**SUBJECT:** Request for Additional Information Regarding  
Extended Power Uprate  
Grand Gulf Nuclear Station, Unit 1  
Docket No. 50-416  
License No. NPF-29

**Grand Gulf Nuclear Station Extended Power Uprate**

**Response to Request for Additional Information**

**Mechanical and Civil Engineering Branch, Steam Dryer (Non-Proprietary)**

Figure 1: Dikers 8x10 SRV with Pneumatic Actuator and Solenoid Air Control Valve

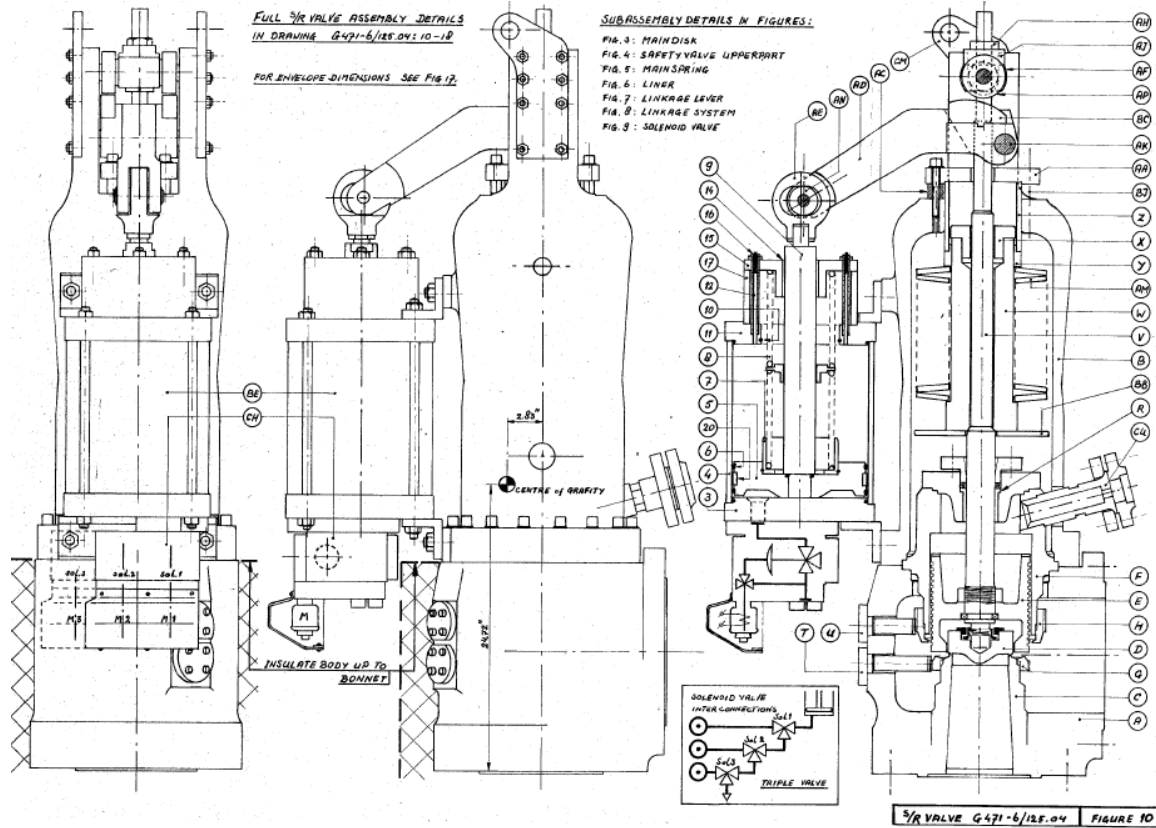
Based on the information provided regarding EPU operation of GGNS, some or all SRVs will be continuously exposed to acoustic resonance in their standpipes at EPU operating conditions. The licensee is requested to explain the measures that will be taken to ensure safe operation of the SRVs and avoid any eventual damage such as those that occurred to the SRVs of the Quad Cities, Unit 2 plant.

3. To ensure the dynamic resistance of the Dikkers SRV is maintained for EPU, the GGNS SRVs are tested and refurbished using proven procedures and experienced craft. It should be noted that plants with SRV vibration issues at EPU also had SRV maintenance issues prior to EPU. To date, the GGNS main steam SRVs have not exhibited any effects of vibration that would be observable as unusual wear or seat leakage, or increased failure rates.

The Dikkers valve, Sempress actuator and Seitz solenoids (See Figure 1) are of a very robust design. Based on GEH and Entergy's knowledge and experience, there have been no vibration-related operability issues with these valves at GGNS or other operating BWRs.

It should be noted that the main steam pressure relief valve damage experienced at Quad Cities Units 1 and 2 from vibration occurred with Target Rock 3-Stage Safety Relief Valves (SRV) and Dresser Electromatic pilot operated Relief Valves (ERV). This damage scenario seems to have been unique to Quad Cities. Based on a review of Operating Experience reports, no other BWR plants have identified a similar failure of an SRV to open due to EPU-related vibration damage.

It is noteworthy that spring Safety Valves are also mounted on the Quad Cities Main Steam lines. There was no reported damage to the Quad Cities spring Safety Valves. GGNS has the Dikkers design SRV. This design is basically a spring Safety Valve with an attached auxiliary actuator. Based on similarity to the Quad Cities spring Safety Valves, the Dikkers SRV is considered more resistant to vibration degradation than the Quad Cities SRVs and ERVs.
